ARCHITECTURAL REVIEW COMMITTEE
AGENDA-SPECIAL MEETING
October 28, 2016
7:30 a.m.

ARCHITECTURAL REVIEW

Agenda Item: Accept the architectural plan with conditions for a four-tenant strip mall structure located at 13499 Elmwood Drive.

Agenda Item: Accept the architectural plan for two multi-tenant structures located at 15146 Dellwood Drive to be known as Northwoods Crossing (city file ARC16-11).

4 A3.1 SOUTH SIDE ELEVATION (FACING JC PENNEY)
1/16" = 1'-0"

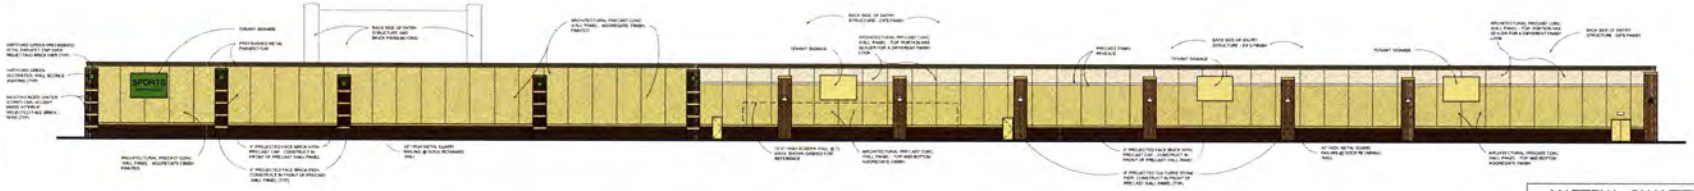
Accessory Structures	Existing building coordinated color	N/A	N/A
Color	Earth tone	Brown, tan, beige, green Franchise colors	OK Unknown
	STAFF COMMENTS: It is unknown whether franchise colors meet the definition of earth tone colors. In addition, it is unknown if accent colors meet or exceed the 10% maximum requirement.		
Height/Roof Design	Flat or 6:12+	Flat	OK
Store Front Projection	**STAFF COMMENTS:** The side elevation views do not show that the store front includes projections with columns, entrance canopies, etc. Staff has been made aware that there may be projections with the store front. The applicant shall update the elevations and site plan if projections are planned.

4) It is unknown whether franchise colors meet the definition of earth tone colors. In addition, it is unknown if accent colors meet or exceed the 10% maximum requirement. The applicant shall provide information on colors and area to verify compliance with these requirements.
5) The side elevation views do not show that the store front includes projections with columns, entrance canopies, etc. Staff has been made aware that there may be projections with the store front. The applicant shall update the elevations and site plan if projections are planned.

3 A3.1 WEST REAR ELEVATION (FACING ELDER DRIVE)
1/16" = 1'-0"

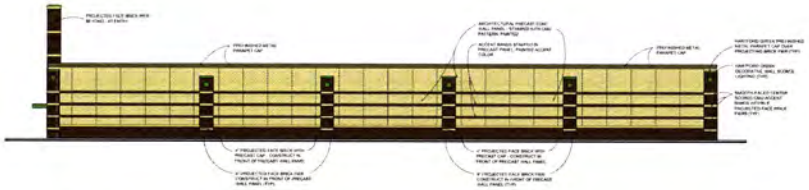
Articulation – West/Rear (facing Elder Drive)	Max 50' Unbroken Expanse for faces >60' and facing street	40-feet wide, articulation provided with projecting stone piers	OK
	STAFF COMMENTS: The sporting goods store includes a parapet that is 18'4". Staff is concerned about the extent of which the backs of the parapets would be visible from the back. Staff recommends that the ARC Commission consider a condition that the developer adds a parapet around the building to limit the view of the back of the parapet. At a minimum, the back of parapets shall include materials and color that match up with the west elevation. The applicant shall revise the elevation to show the loading wall and guard rail for review and approval by city staff. The applicant shall choose 1 wall design for the entire building to provide architectural unity.		
Articulation – North/Side (facing Costco)	Max 50' Unbroken Expanse for faces >60' and facing street	48-feet wide, articulation provided with projecting stone piers and EIFS colonnades	OK

The Architectural Review Commission reviewed the application for architectural compliance with City Code and unanimously recommended approval of the submitted plan dated 5/10/2016 with all of staff comments except the comment regarding the requirement that the applicant shall choose one wall design for the entire building and the comment regarding the requirement that the applicant shall add a parapet wall around the entire building to limit the view of the back of the parapet. The Commission advised that as long as the applicant meets the zoning requirements relating to the back of parapet walls by painting it to match the primary color of the structure, they do not need to incorporate additional elements to lessen the impact of the exposed parapet back.
